STEPHENSON SCHOOL BUILDING

Rehabilitation and Addition

TIRZ PM **Review Comments:** 231018- KES

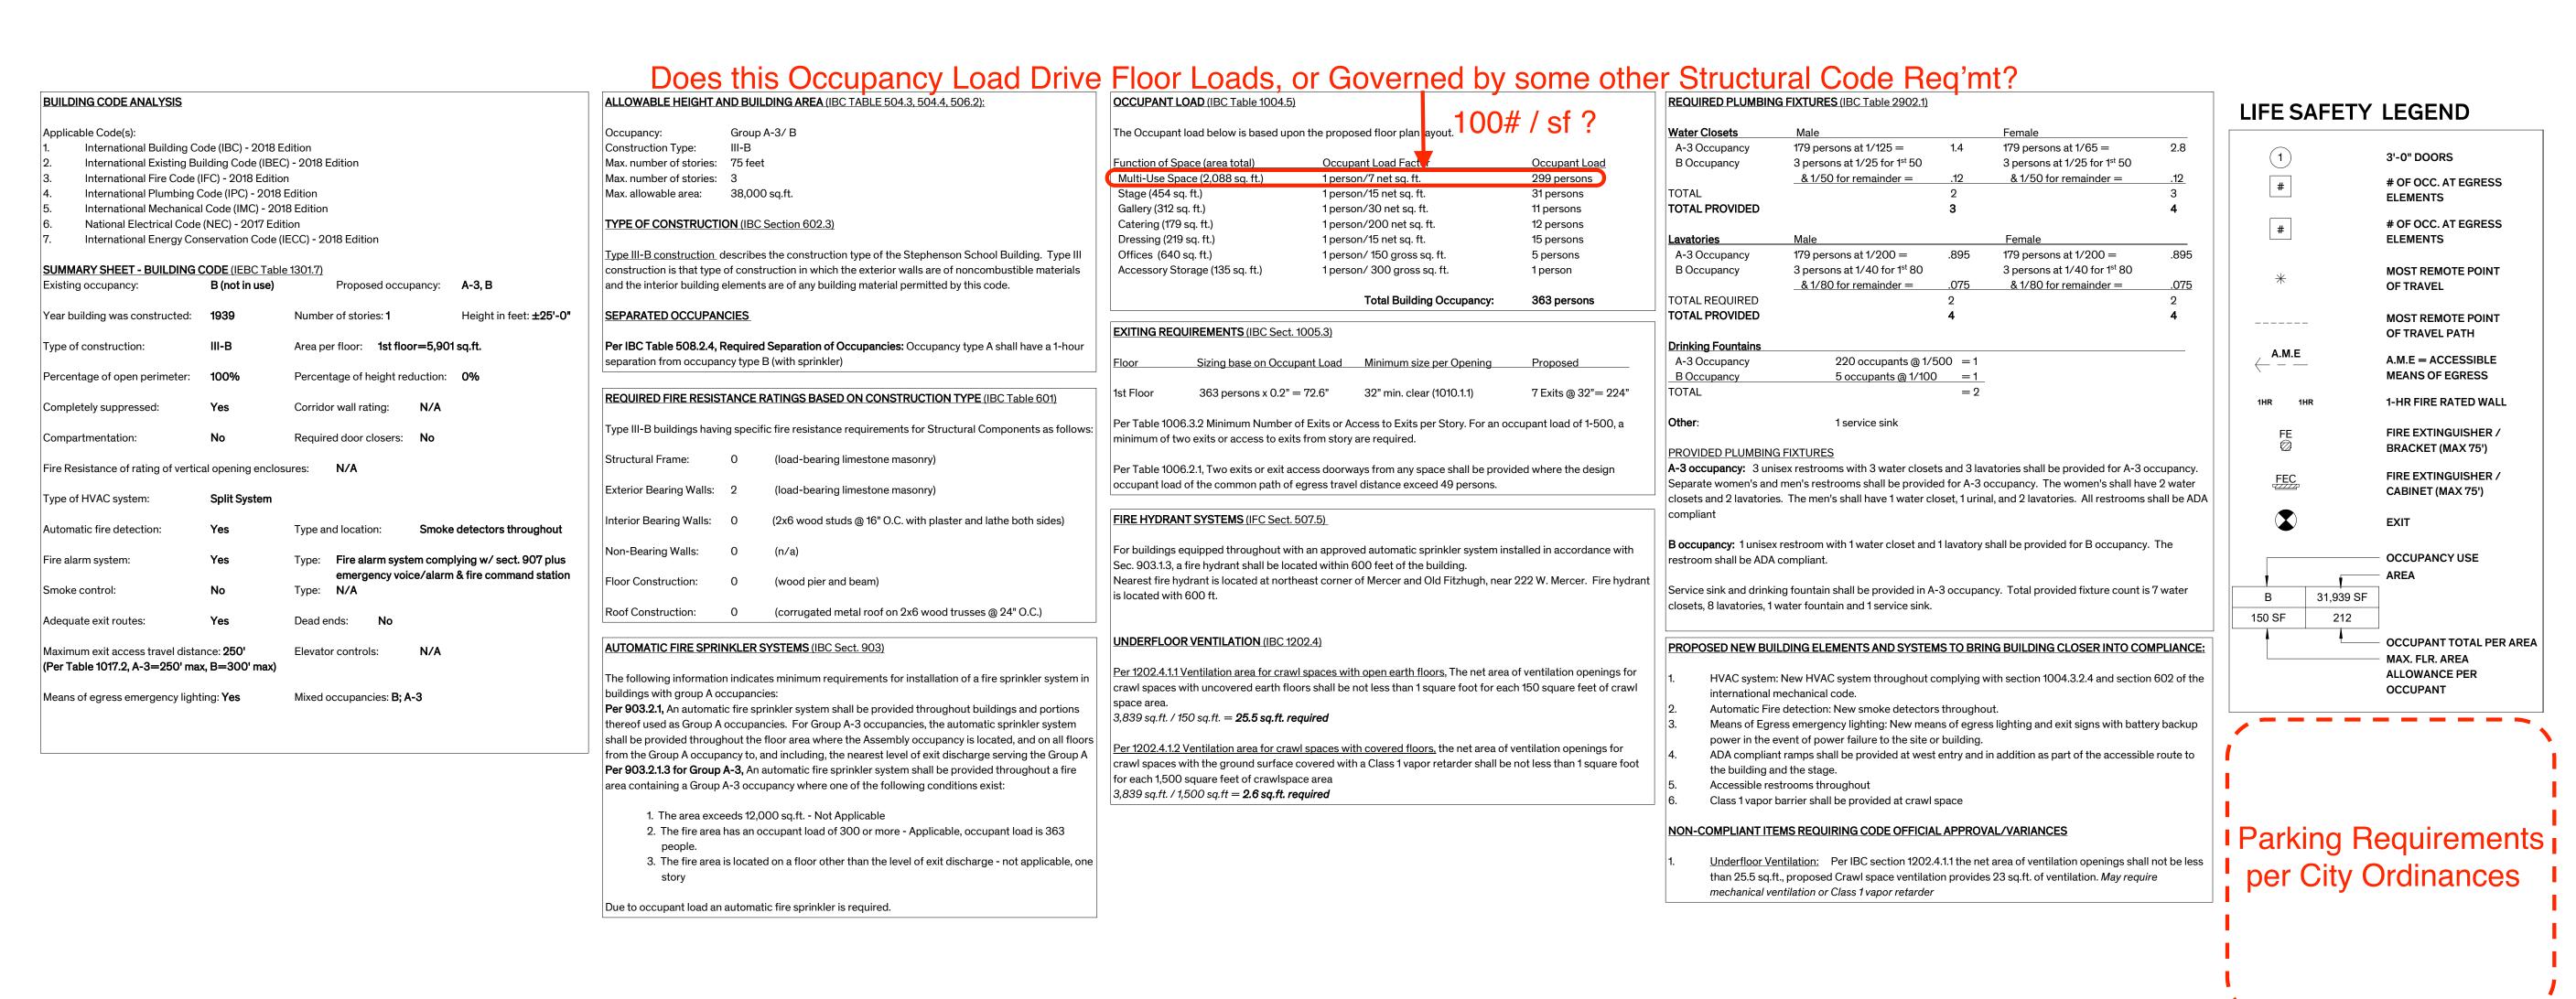
Incorrect RAS CIVIL

Correct per Contract MAP **DOUCET & ASSOCIATES** 7401 STATE HWY 71, B160 AUSTIN, TEXAS 78735 T (512) 583-2600
